FORMAL OBJECTION TO PLANNING APPLICATION DC/26/0945

Reference: DC/26/0945

Proposal: Variation of Condition 1 of previously approved application reference DC/22/0773 (Variation of Condition 1 of previously approved application DC/19/1707) – Amendment to buffer strip to reflect an additional swale with landscaping (part retrospective).

Site: Abingworth Meadows Phase 3, Thakeham

drawing no: BELL23356 - 11 Sheet 4 of 8

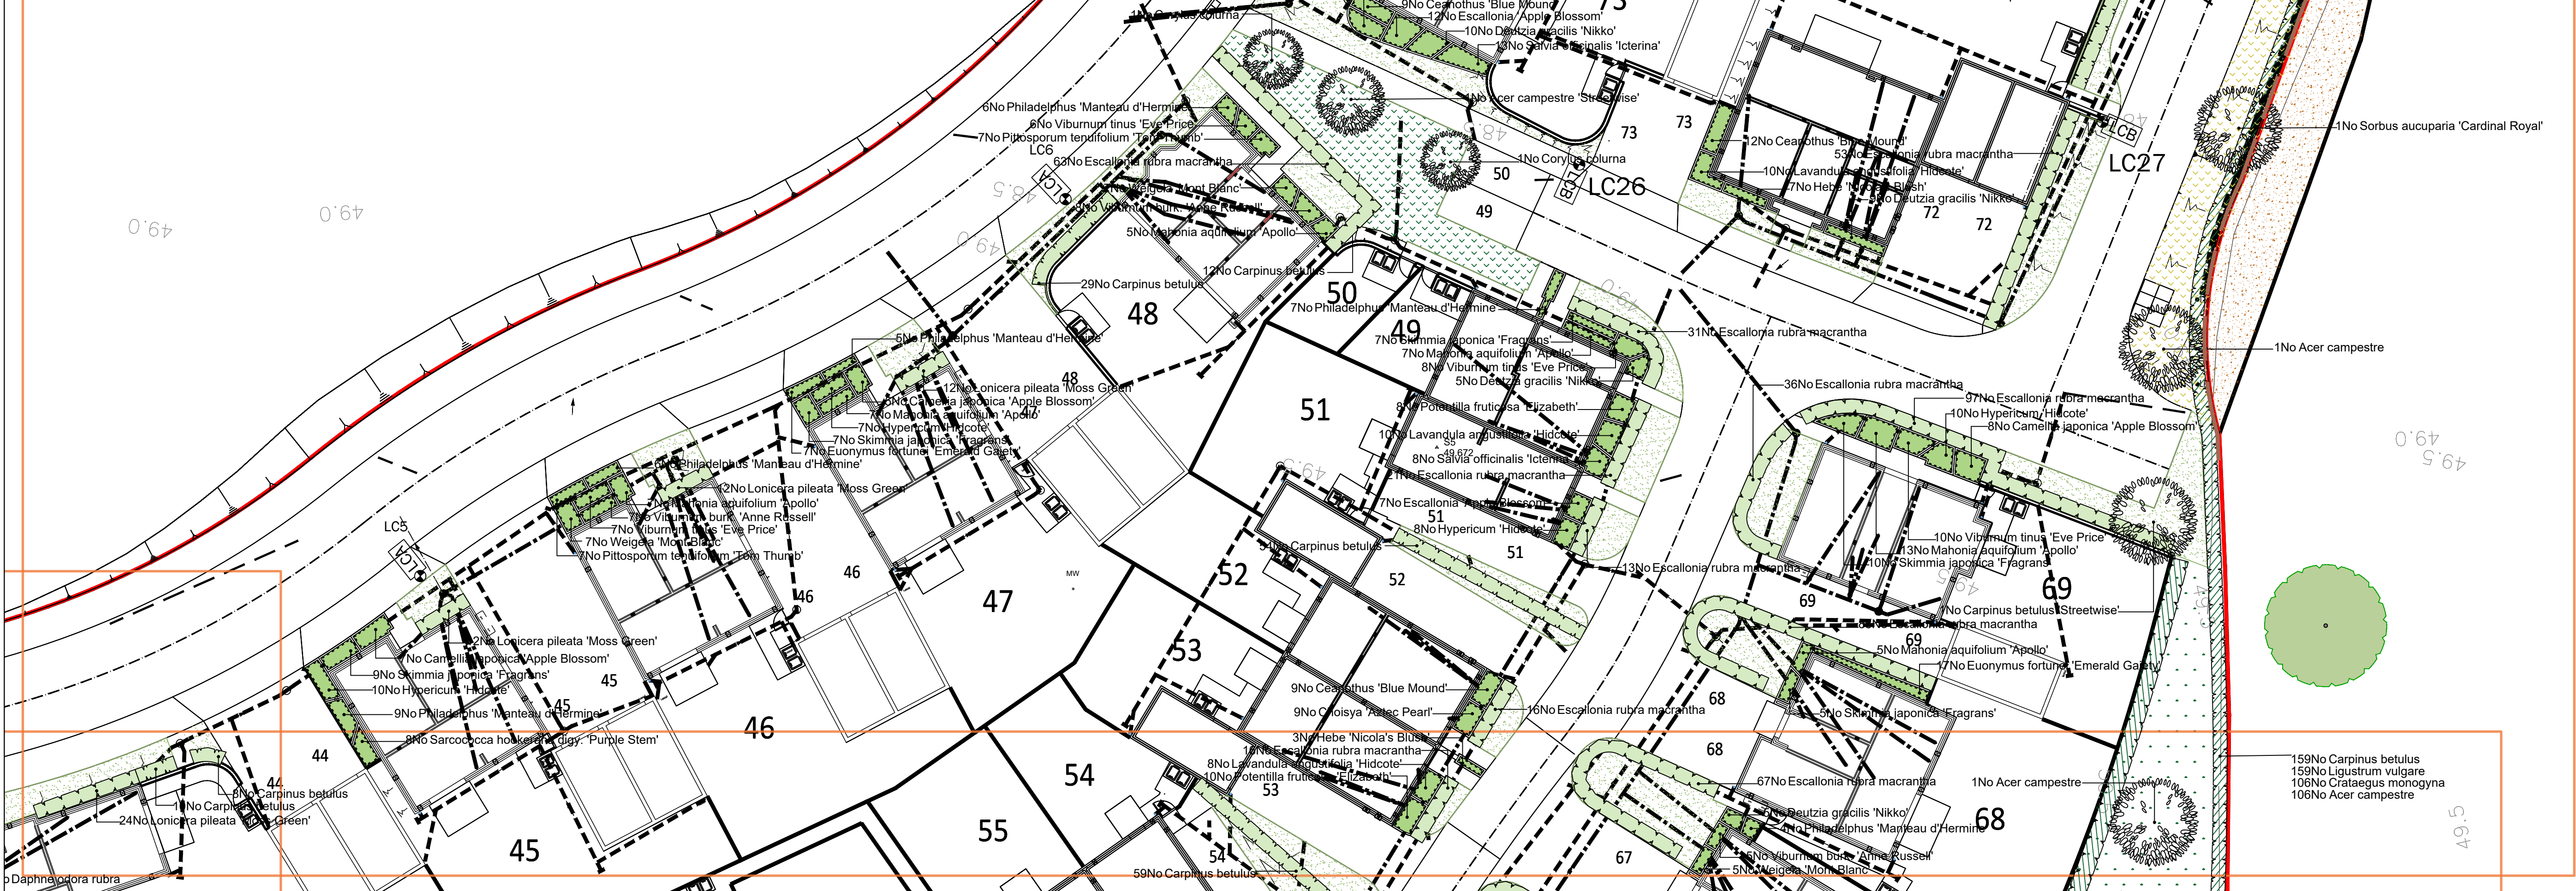
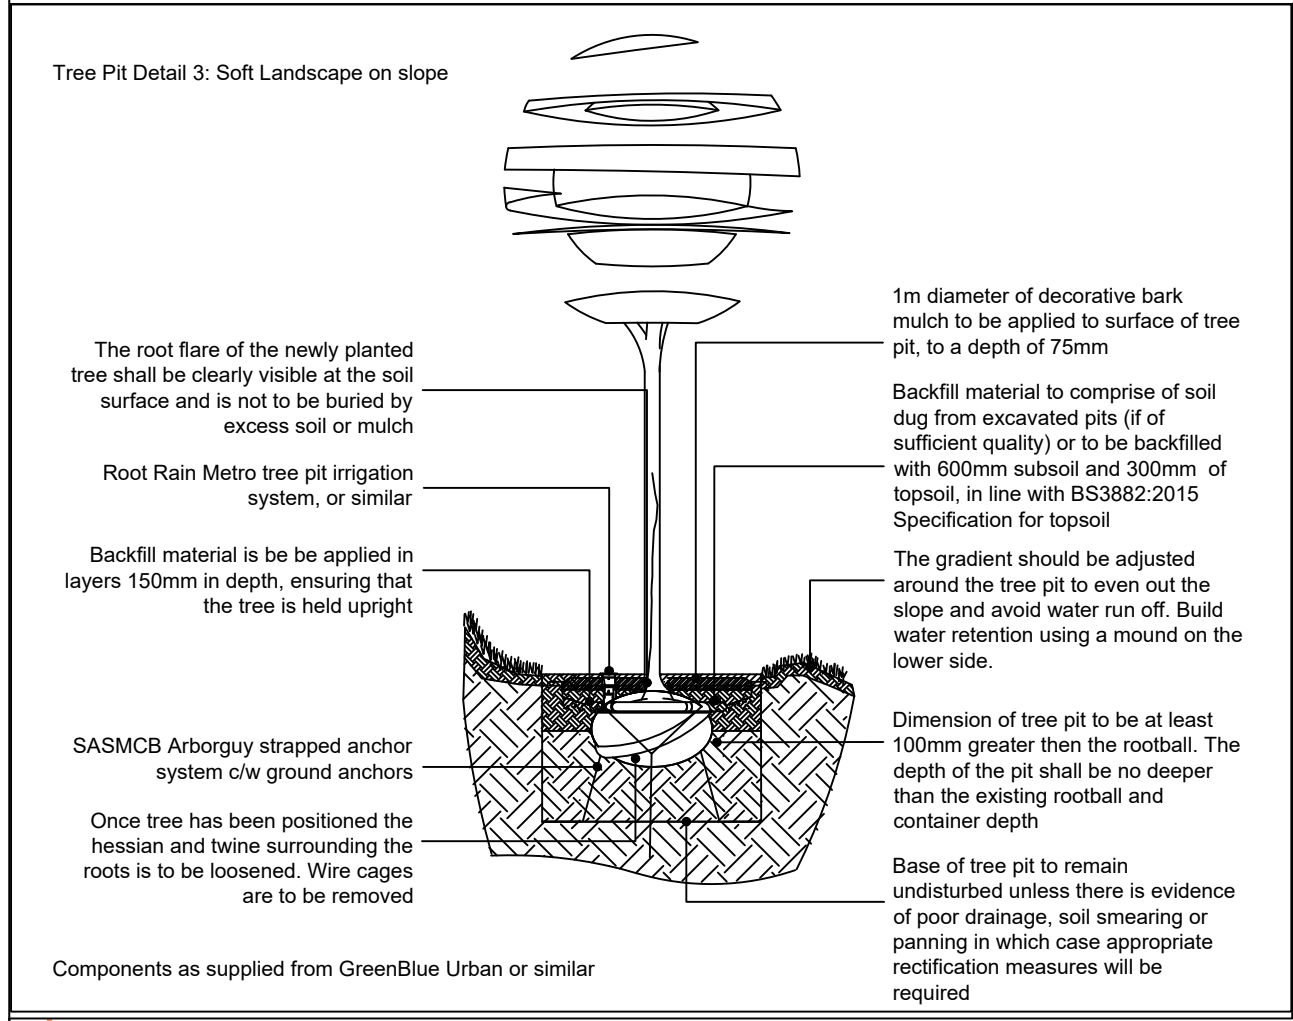
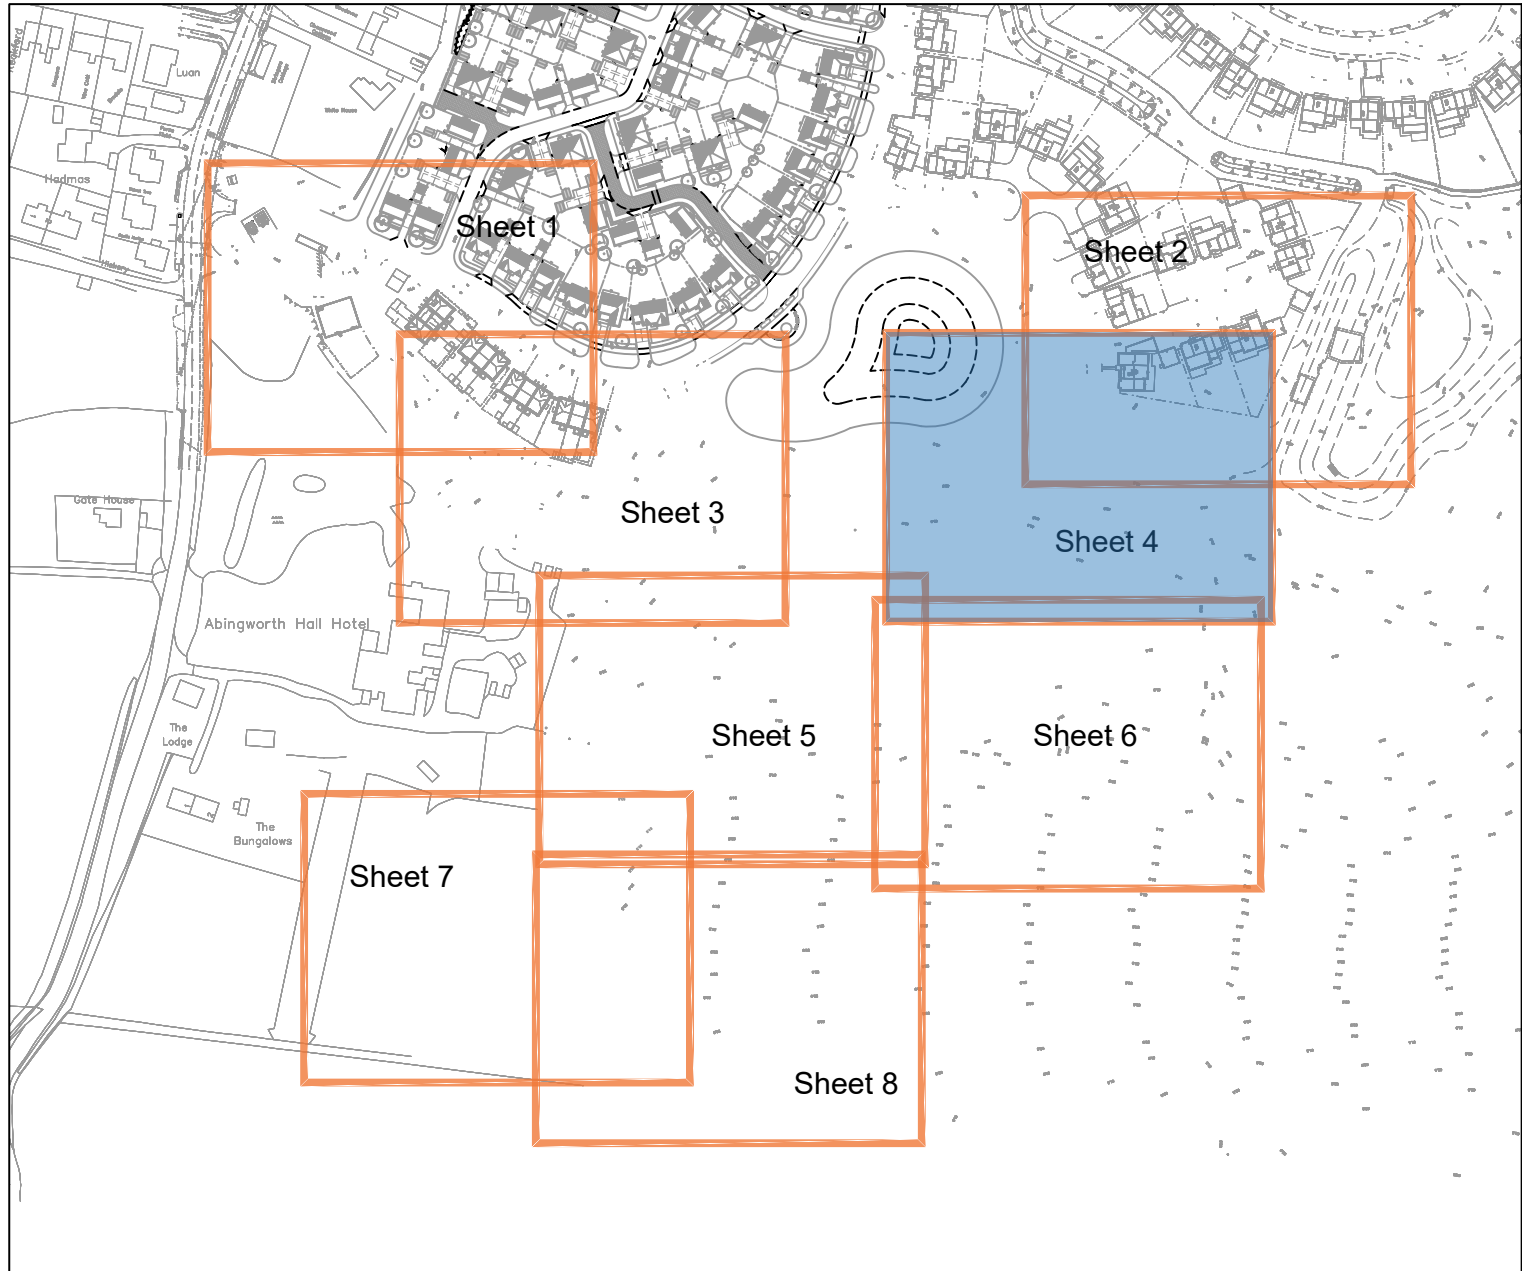
"1.2m high vehicular access five bar timber gate. Approx 4m width" (Drawing BELL23356-11 Sheet 4 of 8)

Residents strongly object to this proposal.

The introduction of a substantial access gate retrospectively changes the character and function of this area.

Immediate removal of the proposed gate.

Residents support the following annotation on Bellway's marked-up landscape plan:

EXISTING FENCE / BARRIER TO REMAIN

FLOOD WATER MITIGATION PROVISIONS TO BE MAINTAINED – ALL OTHER AREAS TO BE LEFT TO NATURE

Drawing BELL23356-11 Sheet 4 Revision J and later Revision N show material alterations to:

Bellway
scheme: Abingworth Nurseries, Phase 3, Storrington Rd
client: Bellway Homes
drawing: Soft Landscape Proposals
date: August 2021
scale: 1:200@A1
drawing no: BELL23356 - 11 Sheet 4 of 8
drawn: JO checked: JM

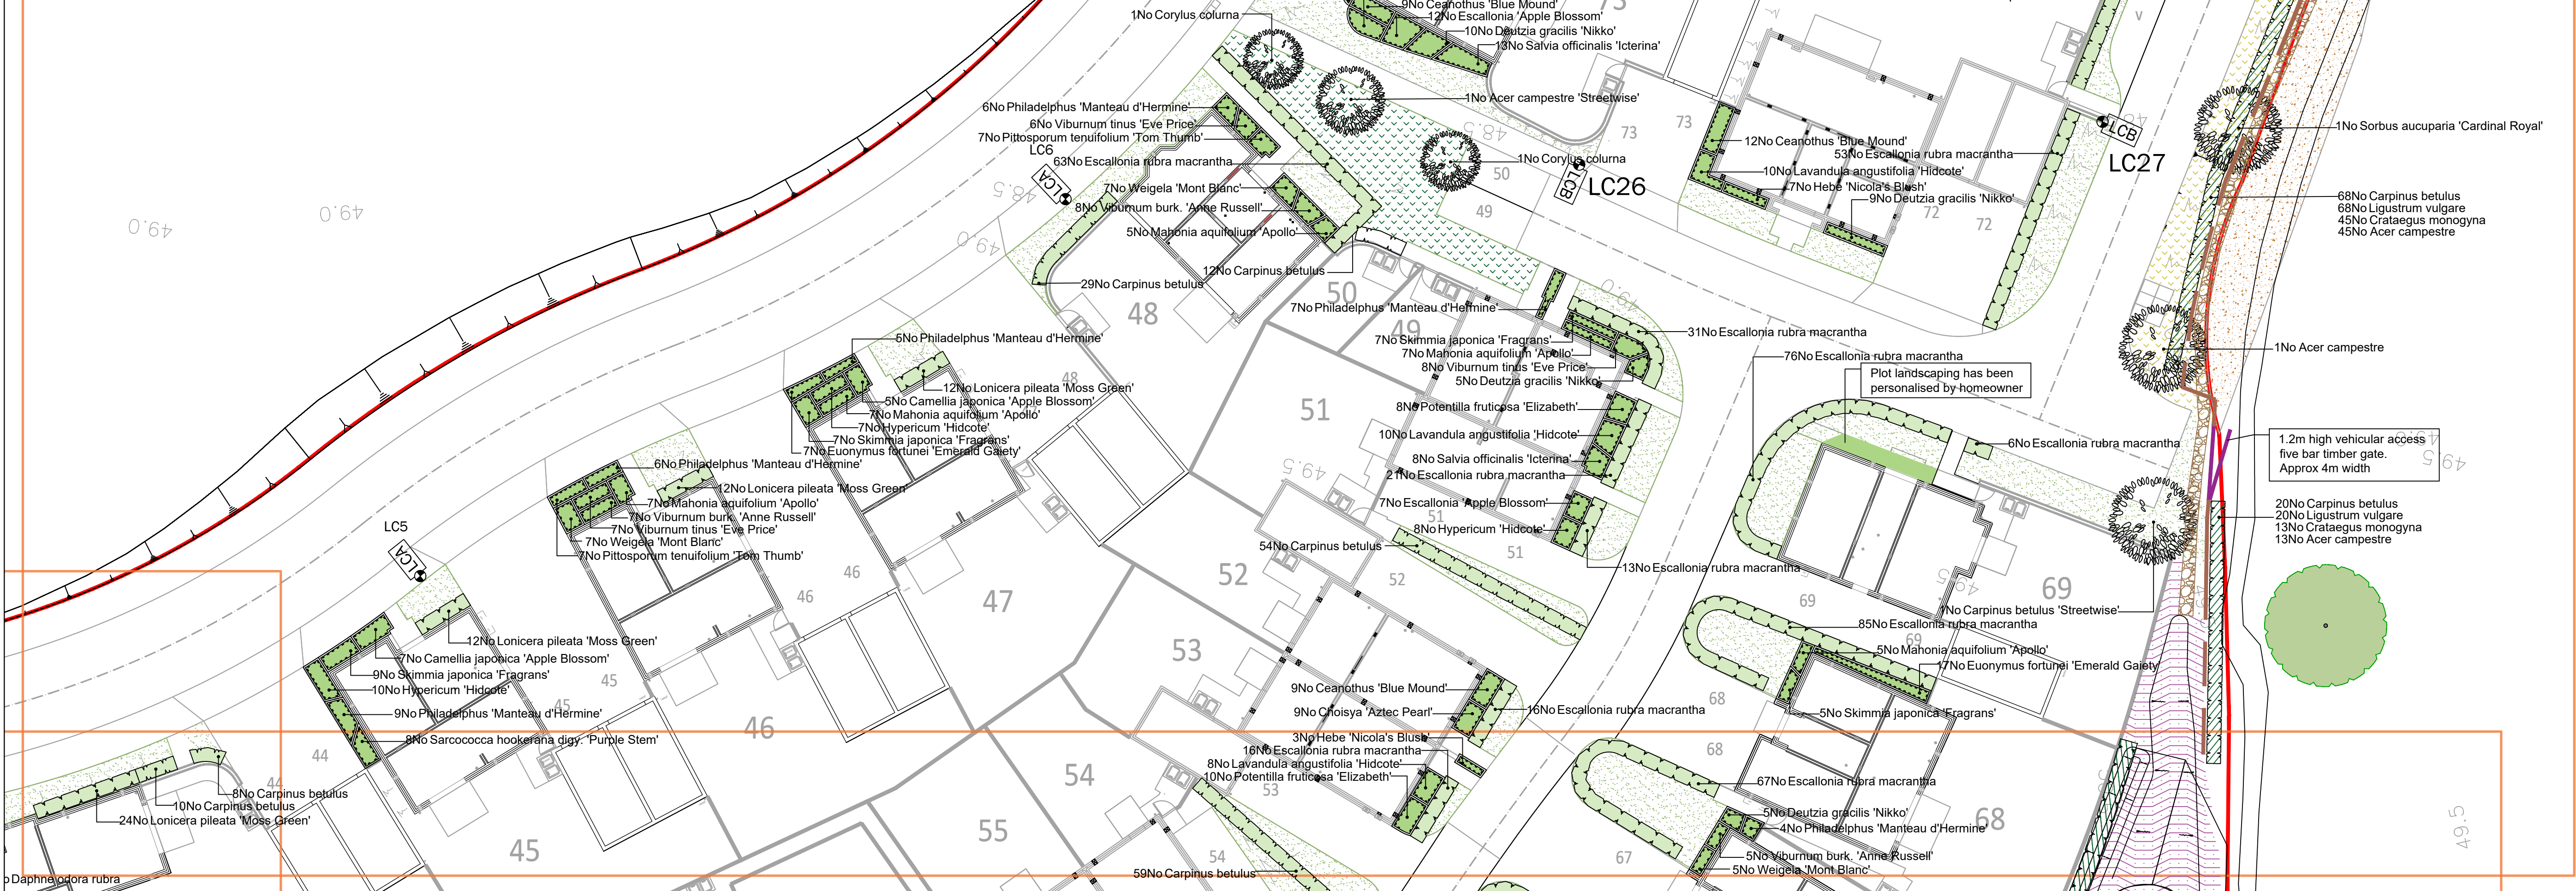
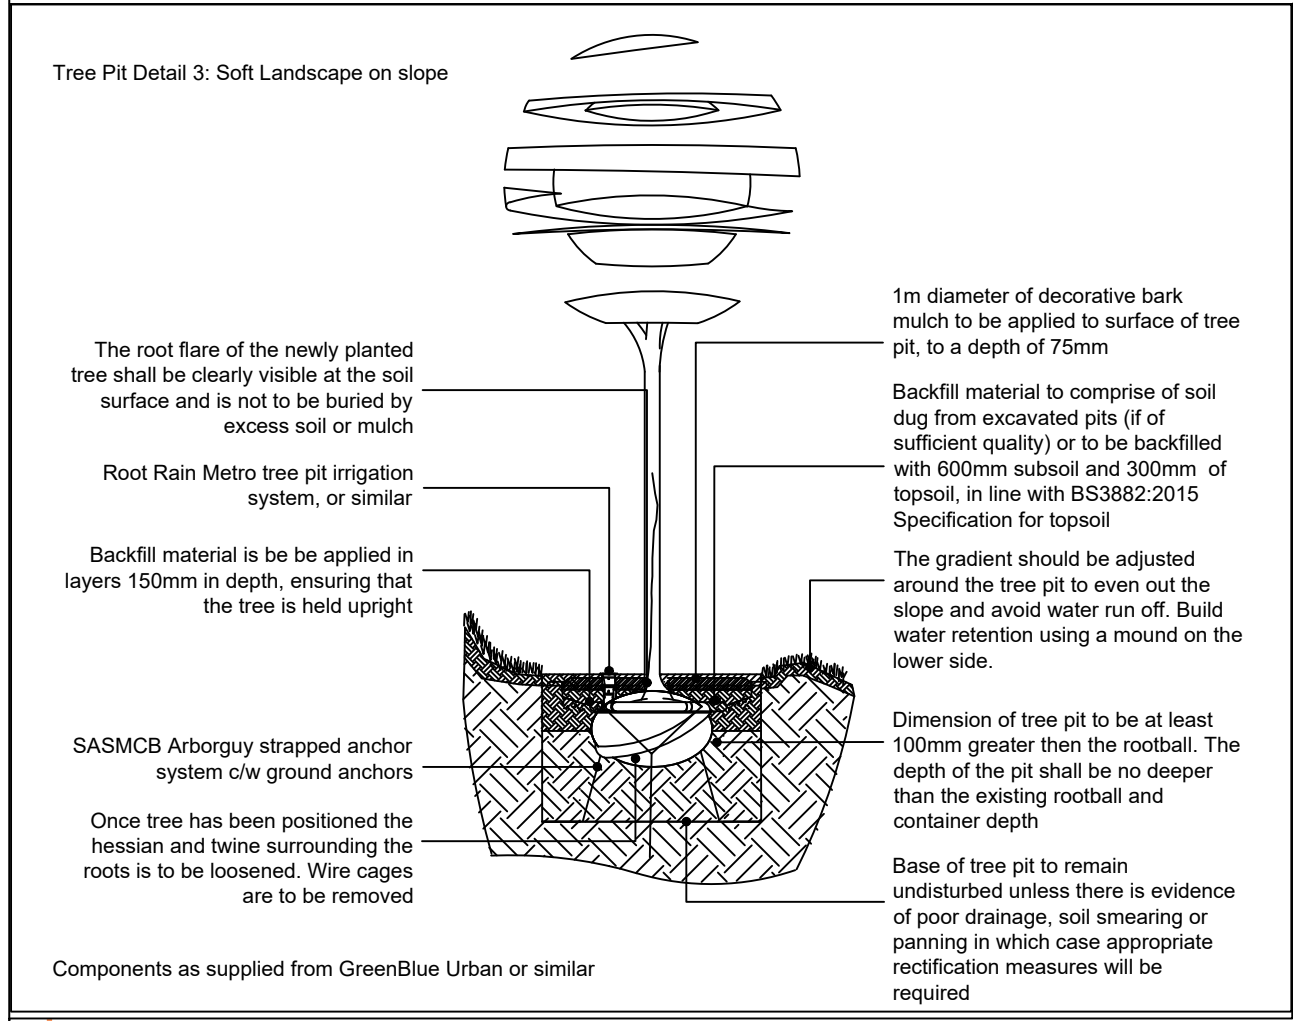
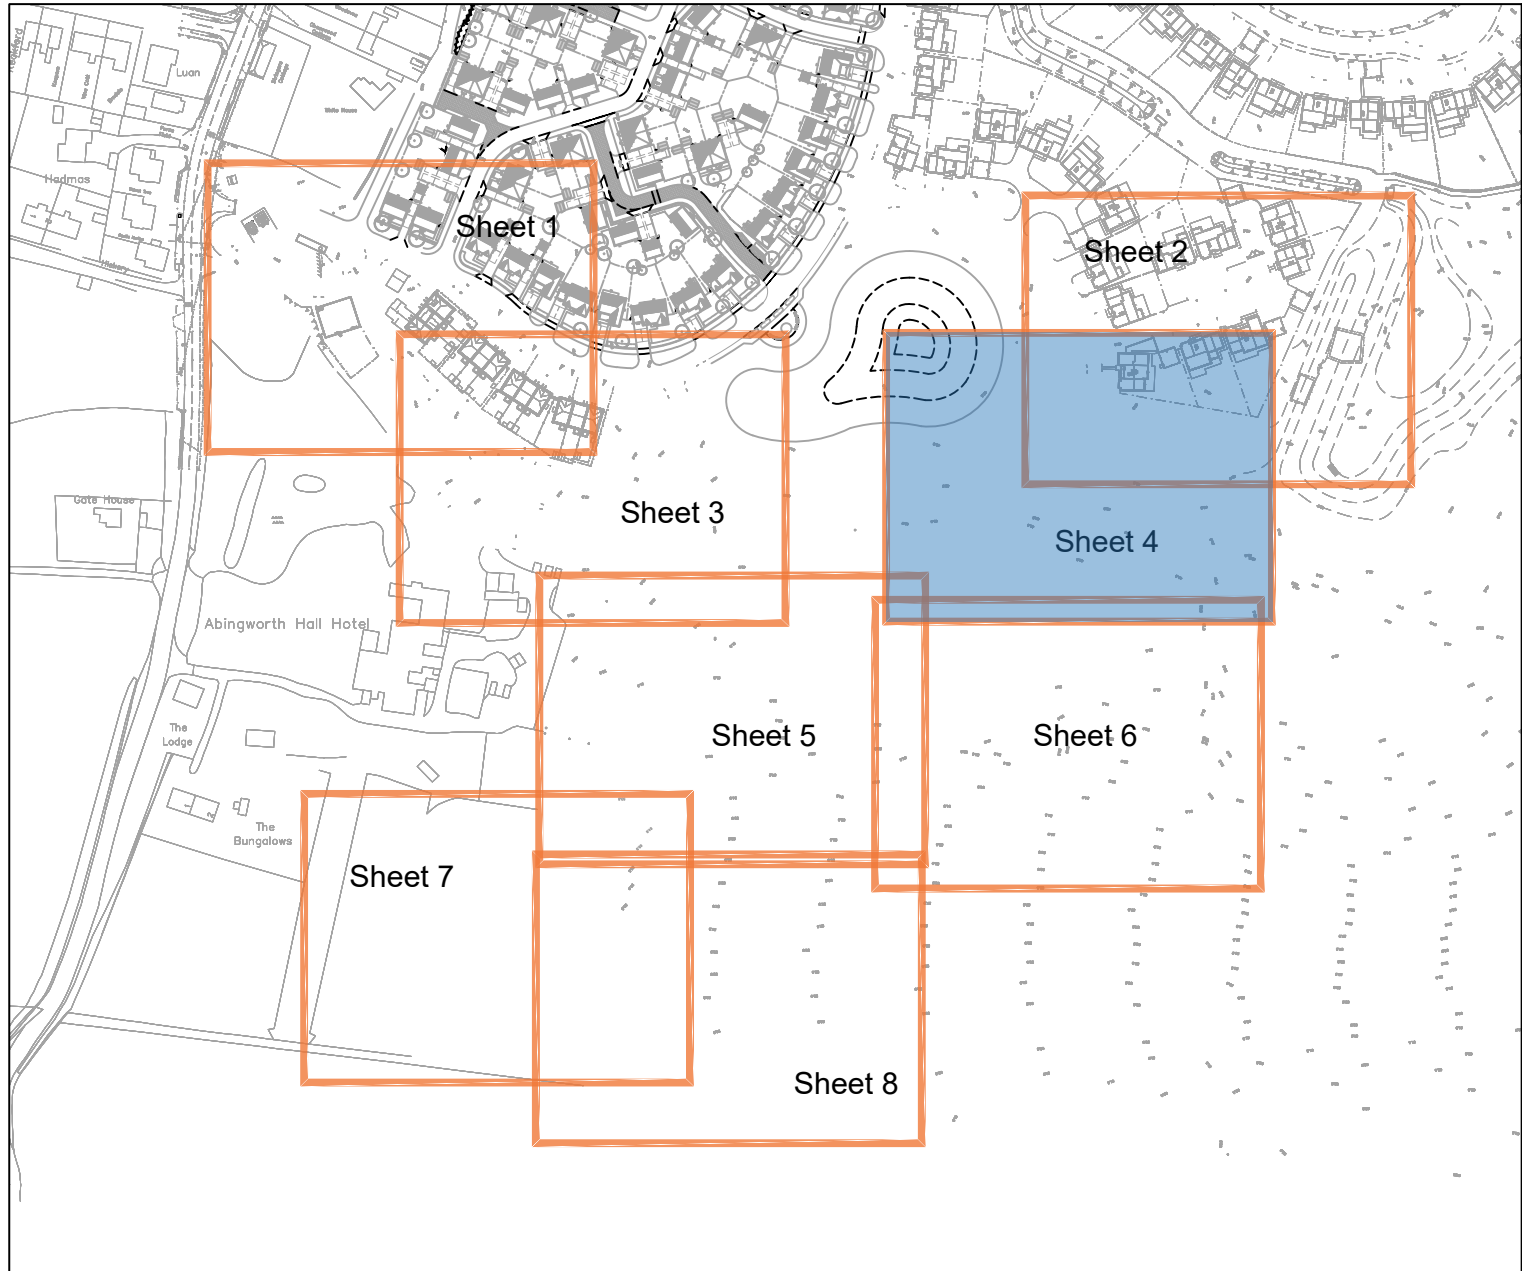
The revised plans fail to include planting previously agreed with Bellway and confirmed through discussions with Carolyn Davies and Ross Gillespie.

The following agreed planting remains absent from Plot 69:

- 10 No Skimmia japonica 'Fragrans'
- 13 No Mahonia aquifolium 'Apollo'
- 10 No Viburnum tinus 'Eve Price'
- 10 No Hypericum 'Hidcote'
- 8 No Camellia japonica 'Apple Blossom'

Native hedge planting along the full rear boundary of Plot 69 comprising:

- double staggered rows;
- rows 500mm apart;
- plants at 400mm centres.
